Industry-NRC Meeting CASS Screening Criteria for Thermal and Irradiation Embrittlement for BWR and PWR Internals

July 15, 2014
NRC Offices
Washington, DC

Comments on NRC Proposed CASS Screening Criteria for Thermal and Irradiation Embrittlement

Figure 1 - NUREG/CR-4513 Lower Bound J-R Curves for 10-15% Ferrite Showing Margin Above 255 kJ/m² at 2.5 mm for CF-3 and CF-8

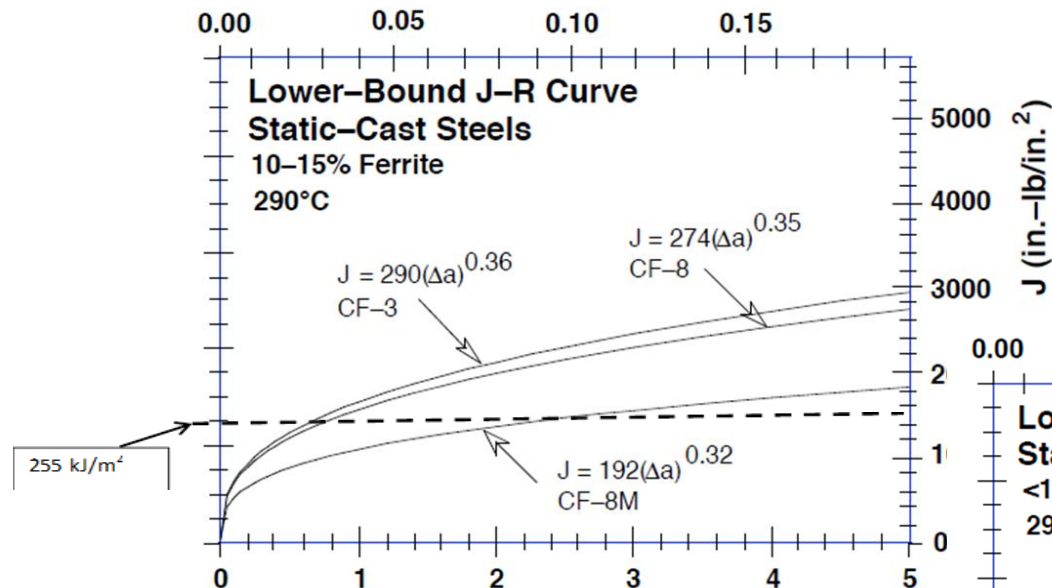
Request Technical Basis for Lower Ferrite Screening Levels in Proposed NRC Guidance

The “NRC staff’s position” section also notes that the staff applies criteria to two different ferrite screening levels depending on neutron “exposure”. The staff suggests changing the ferrite screening to the levels described in NUREG/CR-4513, Rev. 1 (10% and 15% ferrite) from the current ferrite screening levels (14% and 20%) accepted both by the staff and industry for license renewal (e.g., the Grimes letter, MRP-175, and MRP-227-A) without a described technical basis. The basis data for the 14% and 20% screening levels of ferrite are established in industry documentation that clearly states the conservatism used in determining these values and thus it is not clear why additional conservatism (i.e., decreasing the ferrite screening levels to 10% and 15%) is required.

Basis for Reduced Ferrite Screening Levels at > 0.45 dpa

- NRC reduced ferrite content
 - Accounts for uncertainty of end state toughness due to IE+TE
 - NUREG/CR-4513 J-R curves for TE alone show significant margin above 255 kJ/m² at 2.5 mm crack extension at:
 - 10-15% ferrite for low-moly
 - $<10\%$ ferrite for high-moly
- This provides margin for uncertainty wrt additional embrittlement due to fluence

See Figure 1 below for an illustration of the principle. The figure shows there is considerable margin for the lower bound curves for CF-3 and CF-8 above the 255 kJ/m² toughness level at 2.5 mm crack extension. However, for the CF-8M with the same ferrite range, the toughness is right around 255 kJ/m². Therefore, for the CF-8M there is no additional margin for reductions in toughness due to irradiation effects. Figure 2 shows a similar plot for <10 ferrite, which shows even CF-8M has some margin of toughness above 255 kJ/m² at 2.5 mm crack extension.
